Proposal for amendments to ECE/TRANS/WP.29/GRE/2011/61 – Regulation No. 48 (Installation of lighting and light-signalling devices)

The text reproduced below was prepared by the expert from OICA to propose amendments to document ECE/TRANS/WP.29/GRE/2011/61 which concerns Regulation No. 48 in respect to exterior courtesy lamps.

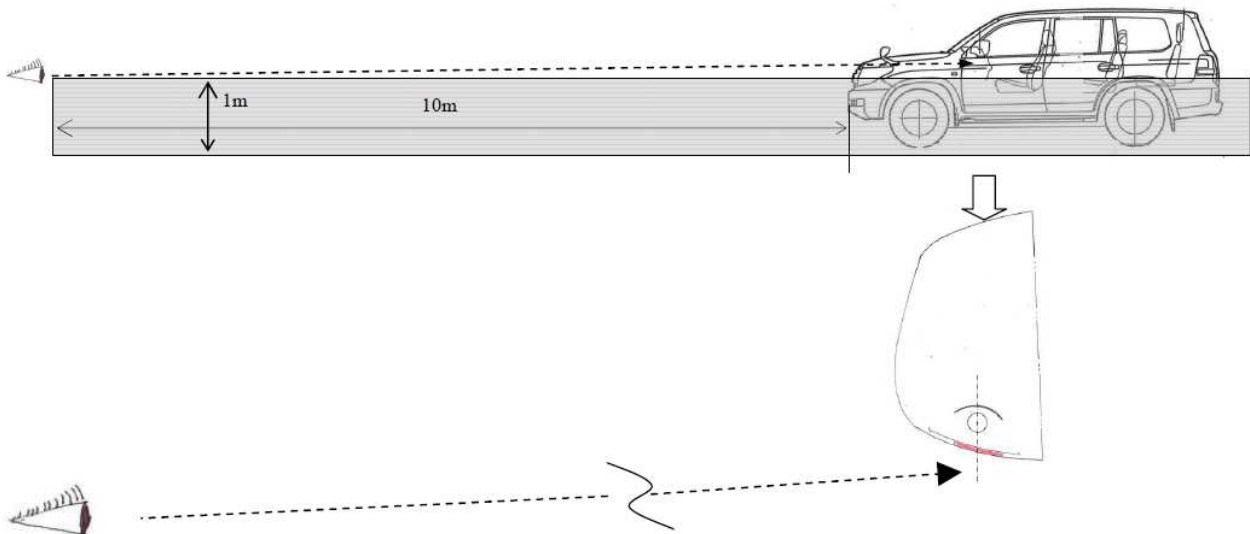
4. The alternative of a maximum activation time is introduced to allow the mounting of exterior courtesy lamps e.g. on the housing of outside mirrors on SUVs or to illuminate steps on commercial vehicles. The requirement in paragraph 6.24.9.3. (Annex 13) is too strict for exterior courtesy lamps installed on outer mirrors of SUVs. (pl. see the drawing below) If the apparent surface is sunk in, it will affect aerodynamic performance and cause wind noise.
